II.6.5 Wonderful Orchards

Re: Comments on Draft Mendota Pool Bypass and Reach 2B Channel Improvements Project
Environmental Impact Statement/Environmental Impact Report

II.6.6 Responses to Wonderful Orchards

Wonderful Orchards New Columbia Ranch Impacts from Alternative B

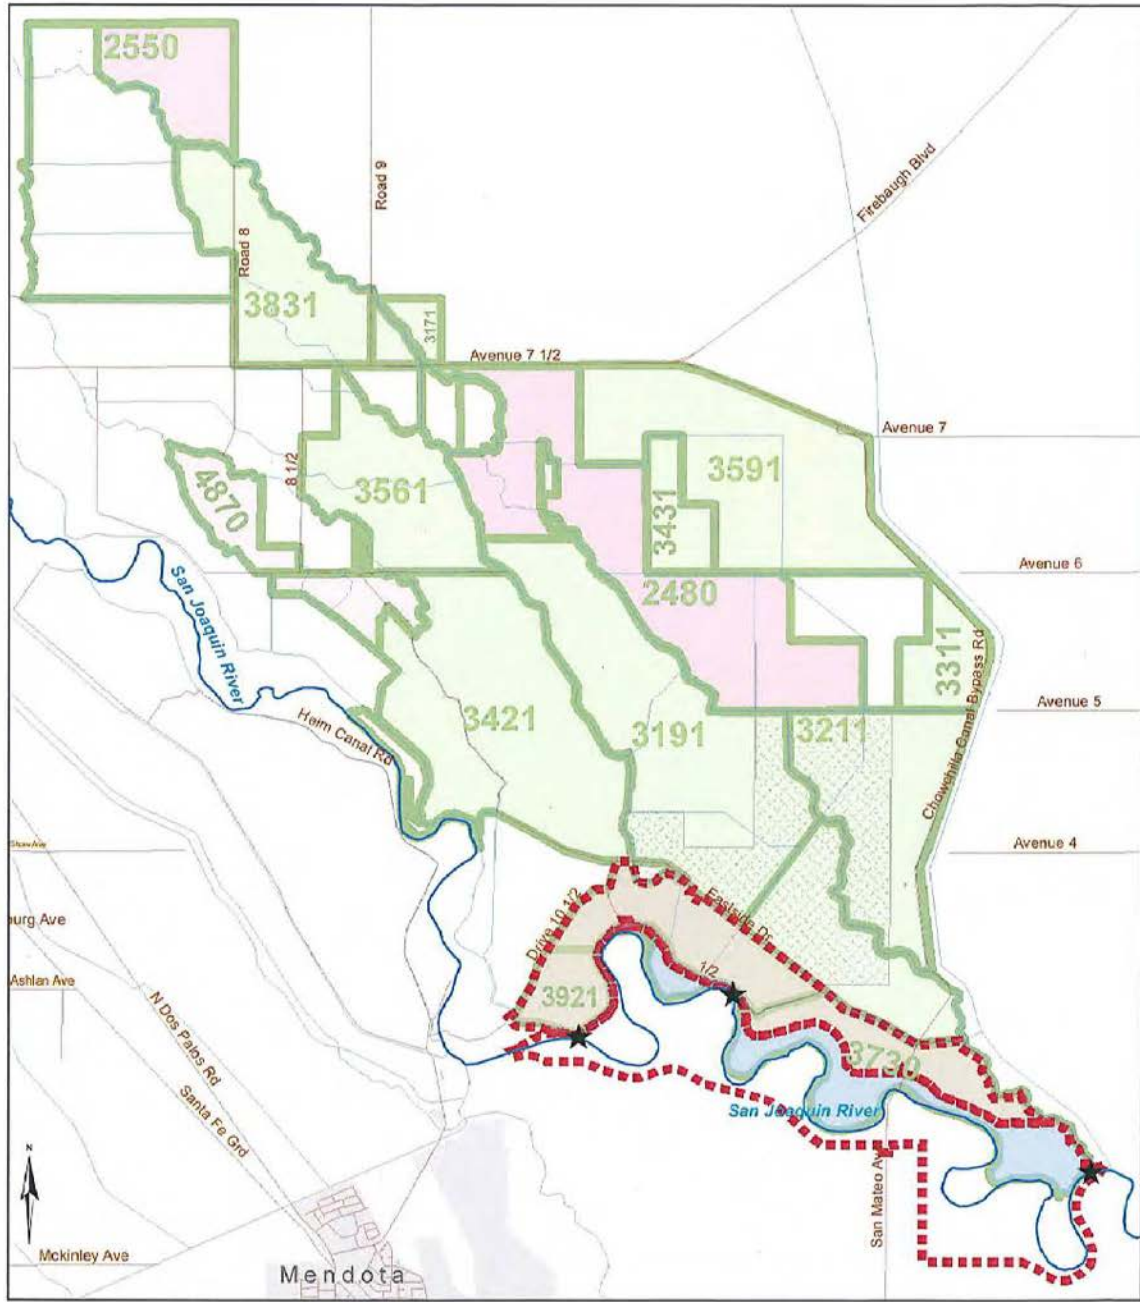
There are numerous ways in which the discussion of impacts on Surface Water could be improved. First, the DEIS/DEIR’s discussion of water rights (see p. 14-28) does not include any discussion of riparian rights or pre-1914 appropriative rights, such as those held by Wonderful. The DEIS/DEIR must include a discussion of these types of water rights, and the Project’s impacts on such rights, in order to be complete. In particular, the expansion of the floodplain area in Reach 2B may interfere with Wonderful’s existing points of diversion along the River at Lone Willow Slough and near River Mile 209 and potentially require construction of additional diversion and conveyance facilities.³

Section 14.2.2 of the Draft EIS/R discusses the California Water Code as it relates to water rights. Riparian rights are mentioned briefly in Section 1.6.3 in context with the Lone Willow Slough Diversion. Section 2.2.4 of the Final EIS/R includes additional information regarding the relocations and floodproofing of existing infrastructure, including lift pumps and canals. The inclusion of this additional information in the Final EIS/R does not change the conclusions of the Draft EIS/R. Potential impacts to these utilities are discussed in Section 23.3.3 of this EIS/R (see Impact UTL-7).
